POTENTIAL NON-CONSERVATISM IN BUTTERFLY VALVE TORQUE PREDICTIONS UNDER COMPRESSIBLE FLOW CONDITIONS.

Vogtle Electric Generating Plant
10 CFR 21 Report
Electric Power Research Institute
Motor Operated Valve Performance Prediction Methodology
Versions 1.0 through 3.2

PPM Software Error Notice 2004-2 (Potential Non-Conservatism in Butterfly Valve Model Predictions under Compressible Flow Conditions)

Figure 2 (cont. on following pages)
Butterfly Valve Disc Shapes (shown to scale) Used in Compressible
Flow Tests Performed by Kalsi Engineering, Inc.

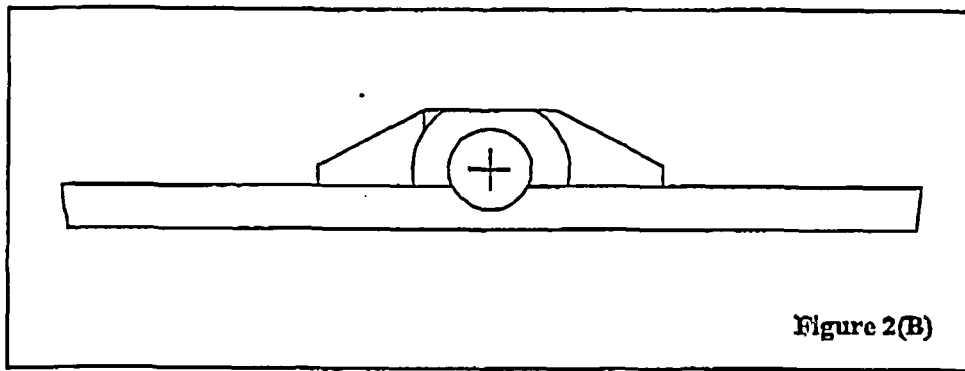
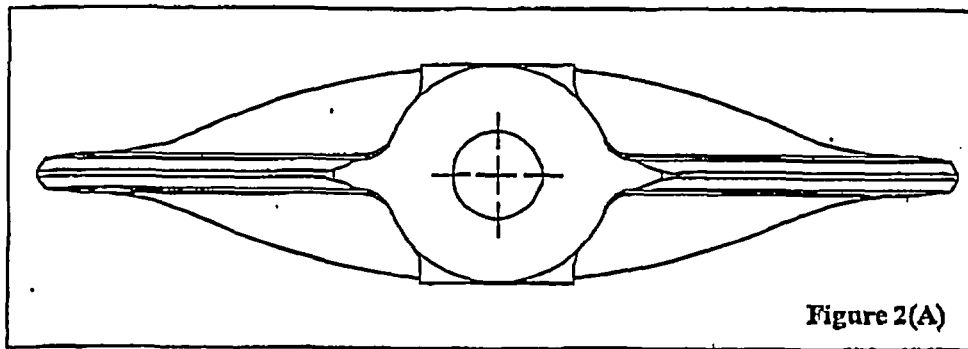
Comparisons completed to date show that under compressible flow conditions, the PPM butterfly valve predictions of maximum required hydrodynamic torque in the closing direction for the disc design shown in Figures 2(C) and 2(D) were found to be non-conservative by as much as 5 percent and 45 percent, respectively. The disc design shown in Figure 2(C) has similar geometric features to those tested by INEL. The disc design shown in Figure 2(D) is somewhat different than the INEL test valves disc shapes used to validate the PPM for compressible flow conditions, in that it has a shallow concave recess in the front face. The reported non-conservatism in hydrodynamic torque is based on limited comparisons between the PPM predictions and test data. Under compressible flow blowdown conditions, the hydrodynamic torque is the major component of the total required dynamic torque that is used for actuator sizing

Table 1 shows the applicability criteria for the PPM Butterfly Valve Model (Reference 1, page 7-24). The Table indicates applicable disk designs must have prismatic or conical back faces and flat front faces. The disk shown in Figure 2(C) is clearly applicable for PPM evaluations based on these criteria. The disk shown in Figure 2(D) has a shallow concave recess in the front face. Reference 2, page 2-1, under Terminology: Non-symmetric disk with single offset stem states, "The disk face away from the stem is typically flat or has a small curvature and is commonly referred to as the flat face". Based on this statement, the shallow concavity of the disc shown in Figure 2 (D) can be interpreted to be within the applicability of the PPM. Table 1 also indicates that the disc must have a prismatic or conical back face. The disc shown Figure 2(D) has features that could be interpreted as being prismatic and therefore within the applicability of the PPM.

1. Pending further EPRI evaluation, for butterfly valves with non-symmetric discs with the shaft in the downstream orientation, in compressible flow applications and in the closing direction, use of the PPM Butterfly Valve Model should be restricted to valves with a completely flat front face, e.g., the PPM butterfly model shall not be applied to butterfly valves with a recessed (curved or flat) front face.

1. For butterfly valves with non-symmetric discs with the shaft in the downstream orientation, in compressible flow applications and in the closing direction, meeting all PPM applicability requirements and accounting for the restriction described above, the predicted maximum required total dynamic torque shall be multiplied by 1.05.

- If the front face is recessed, the user should evaluate the potential impact of a 45 percent increase in the maximum total required dynamic torque prediction.
- If the front face is truly flat and is not recessed, the user should evaluate the potential impact of a 5 percent increase in the maximum total required dynamic torque prediction.
